project
Wivelsfield Village Hall
Extensions

drawing
WINDOW SCHEDULE
SHEET 2
WG12-15B

job no	dwg no	revision
C-1732 (31)002		T2

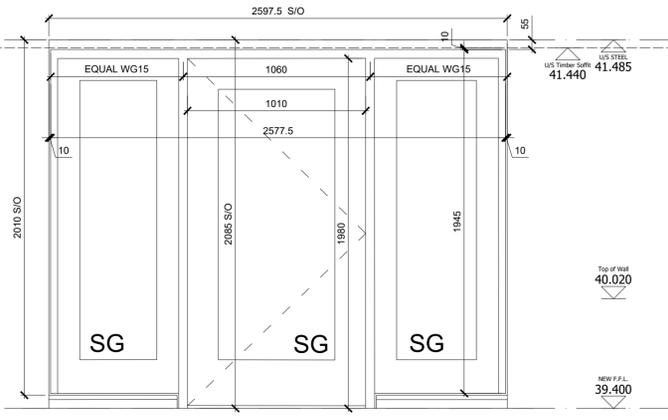
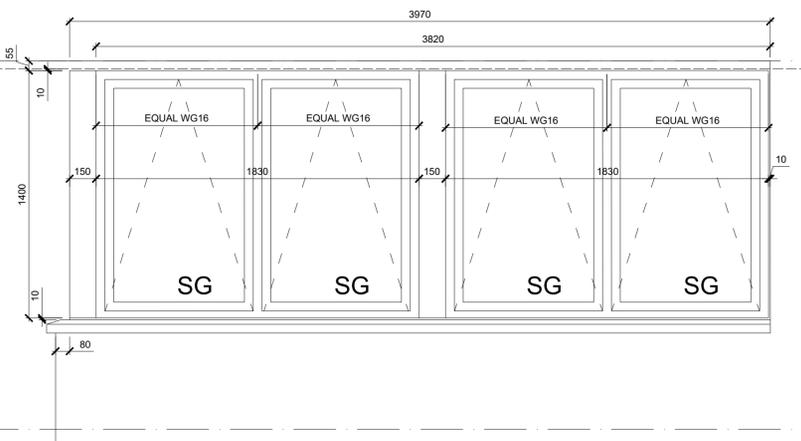
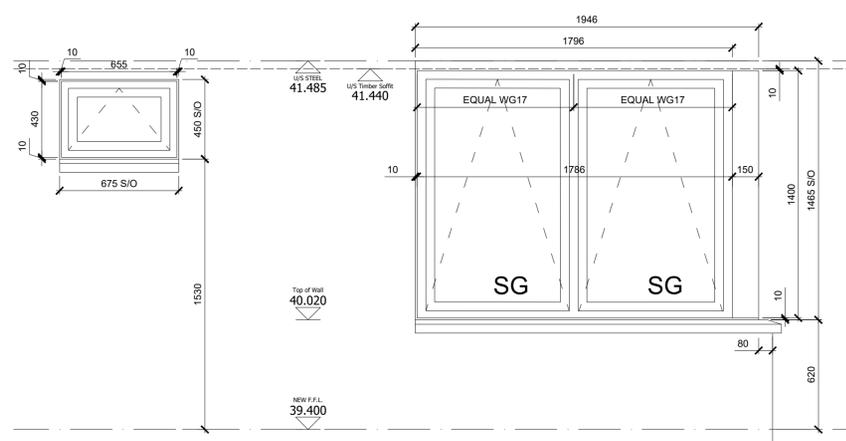
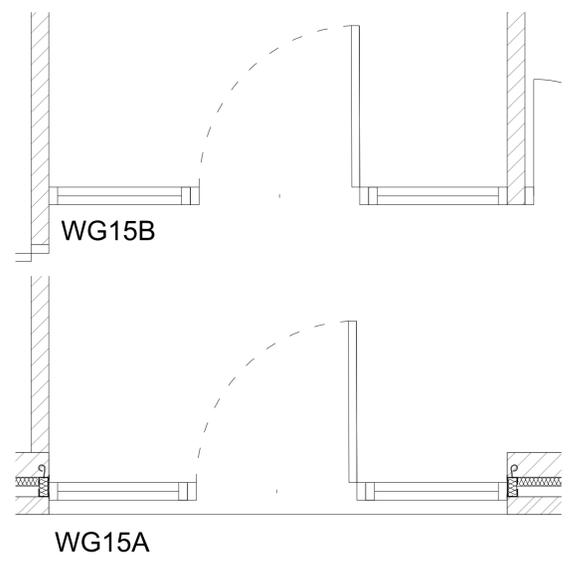
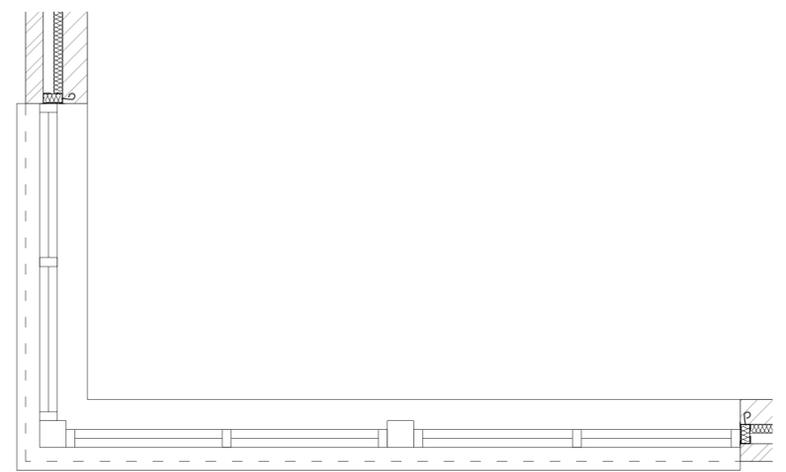
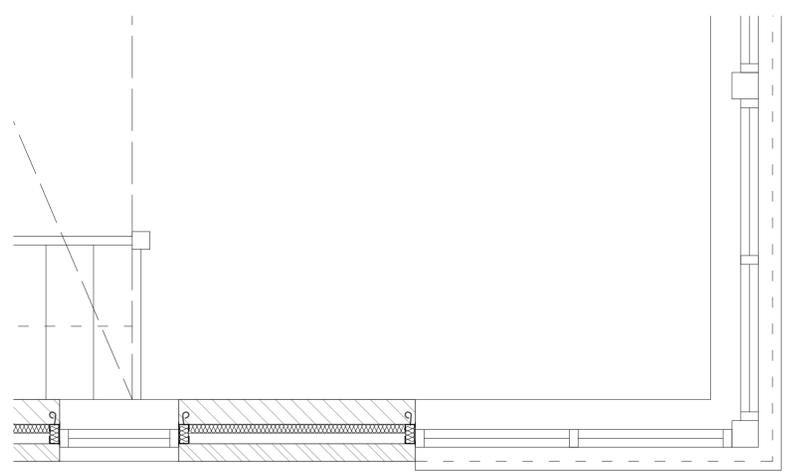
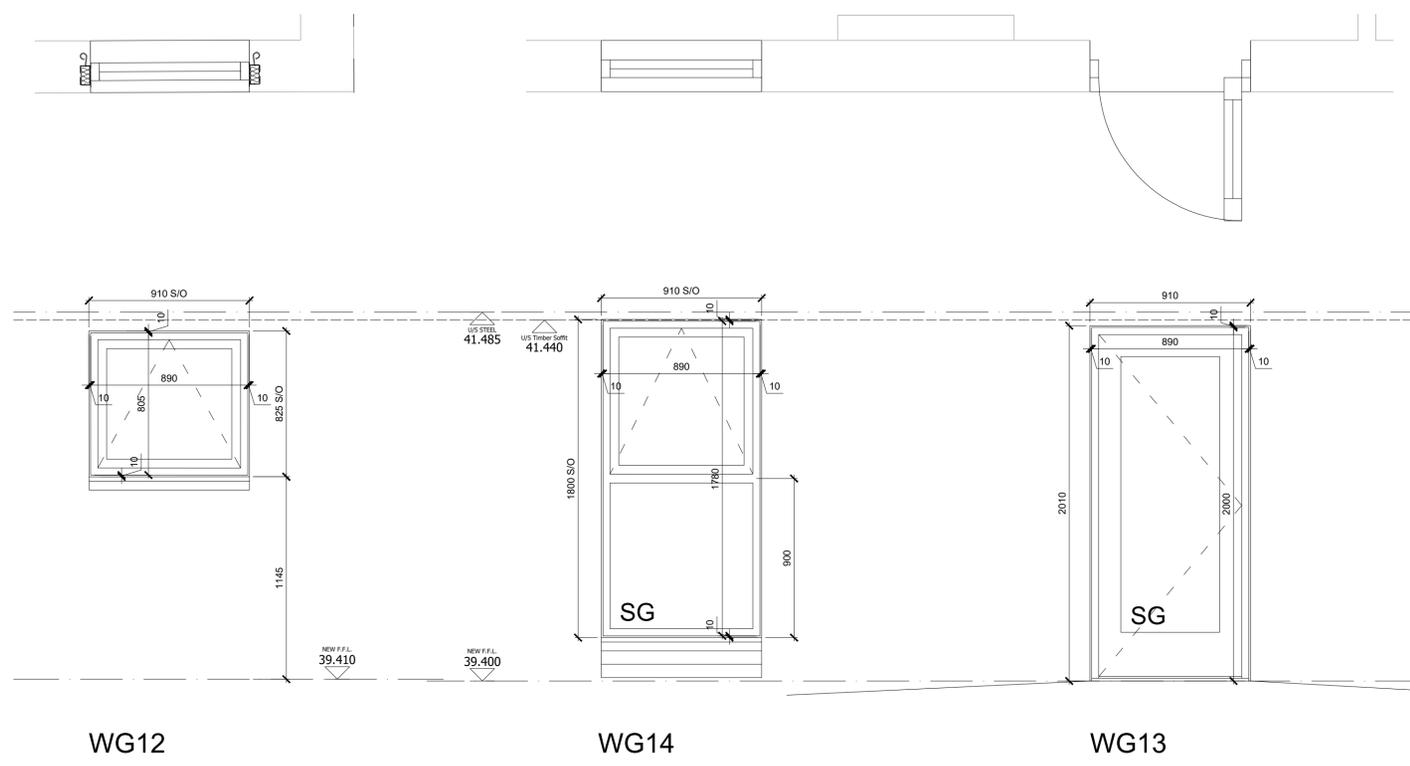
rev	date	amendment	dwn	chkd
A	26.05.20	New kitchen-store made smaller and window WG12 omitted	sk	gt
B	18.06.20	Kitchen window WG15 shown - existing to be re-used, as clients instruction	gt	gt
T2	16.07.20	Note added ref ex. toilet windows to be replaced as per new type	gt	gt

Rev.T2:
WG.19 and WG.20, not drawn, are replacement windows to existing toilets, as per new windows in material, colour and top hung operation, with all U value, safety and restrictor features, fitted to existing opening. To be measured and confirmed on site prior to ordering. Both are to be obscure glazed in large Flemish pattern. See existing elevations

WG.15 is the existing window in the east elevation of the kitchen. To be carefully removed and re-used / re-fixed in the new east wall to the extended kitchen area.

Sizes to be ascertained following removal as frame is partly obscured by existing construction.

Provide a timber lining externally, 25mm thick, stained as timber cladding. Internal lining to reveal to be painted softwood.
